Permit Type	Permit Number	Opened Date
Building/Residential/Misc/Pool Spa	B23000785	03/08/2023

Description of Work
SFD/INSTALL 12' X 16', DEPTH 3' TO 4' fiberglass bottom inground pool at the rear of the home with an existing fence

From: Oswald, Hank
Sent: Wednesday, March 15, 2023 2:17 PM
To: 'info@splashfiberglasspoolcompany.com'
Cc: 'janasikservicesllc@gmail.com'
Subject: B23000785_15050 Frederick Road
Attachments: A59289-A_04-327195_15050_FREDERICK_ROAD.pdf; Plot Plan.pdf

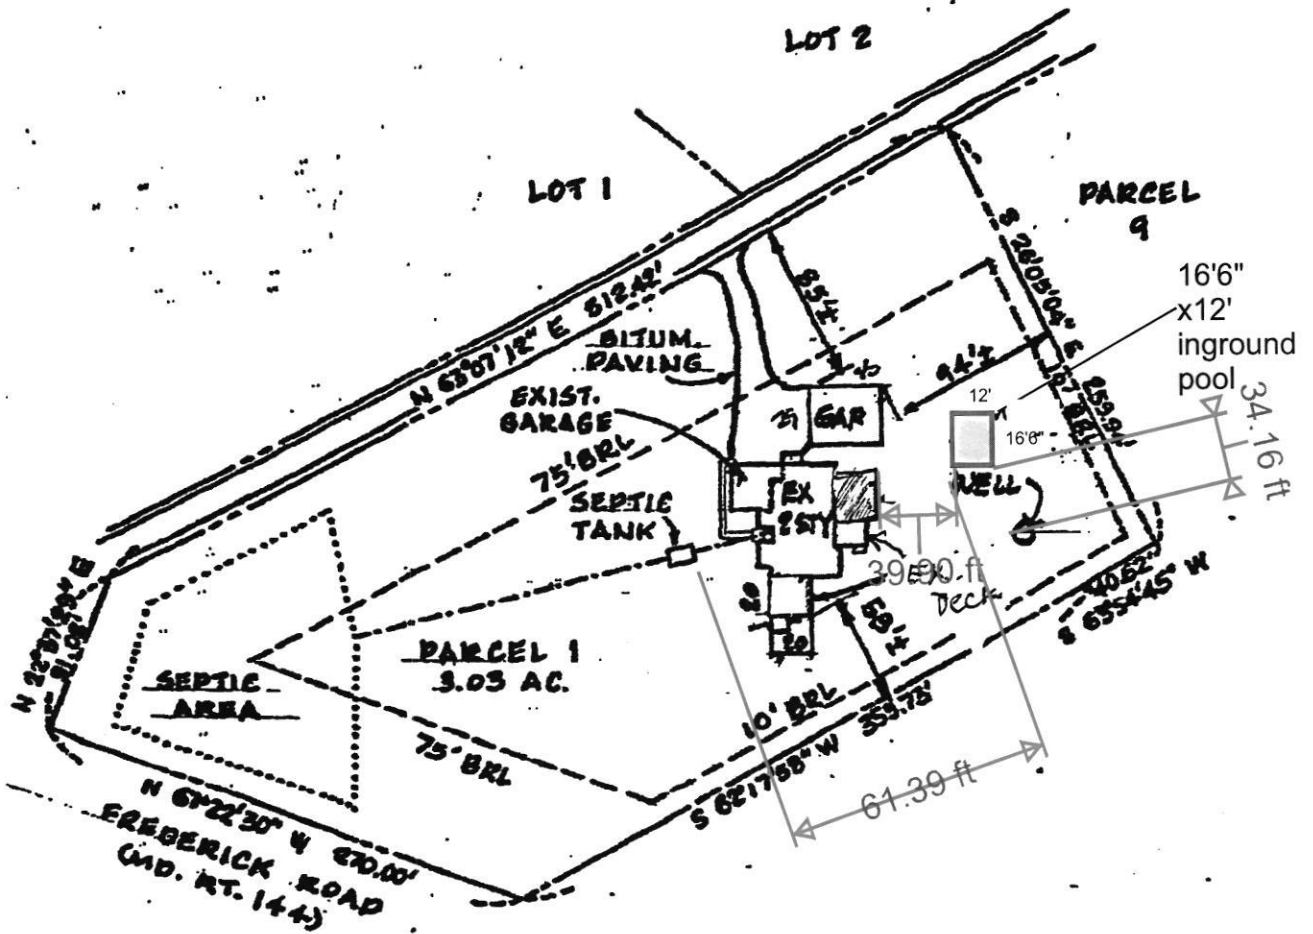
Per our telephone discussion, the site plan for building permit # B23000785 (swimming pool) did not include the pool location and the septic tank location is incorrect. I've attached a copy of the septic record for this property. Please plot the septic tank (per the as-built page#2), the swimming pool location, and remove the new sunroom note on your site plan (attached), and resubmit the revision to the permits office. Please let me know when you have submitted the revision, so I can look for it in the system.
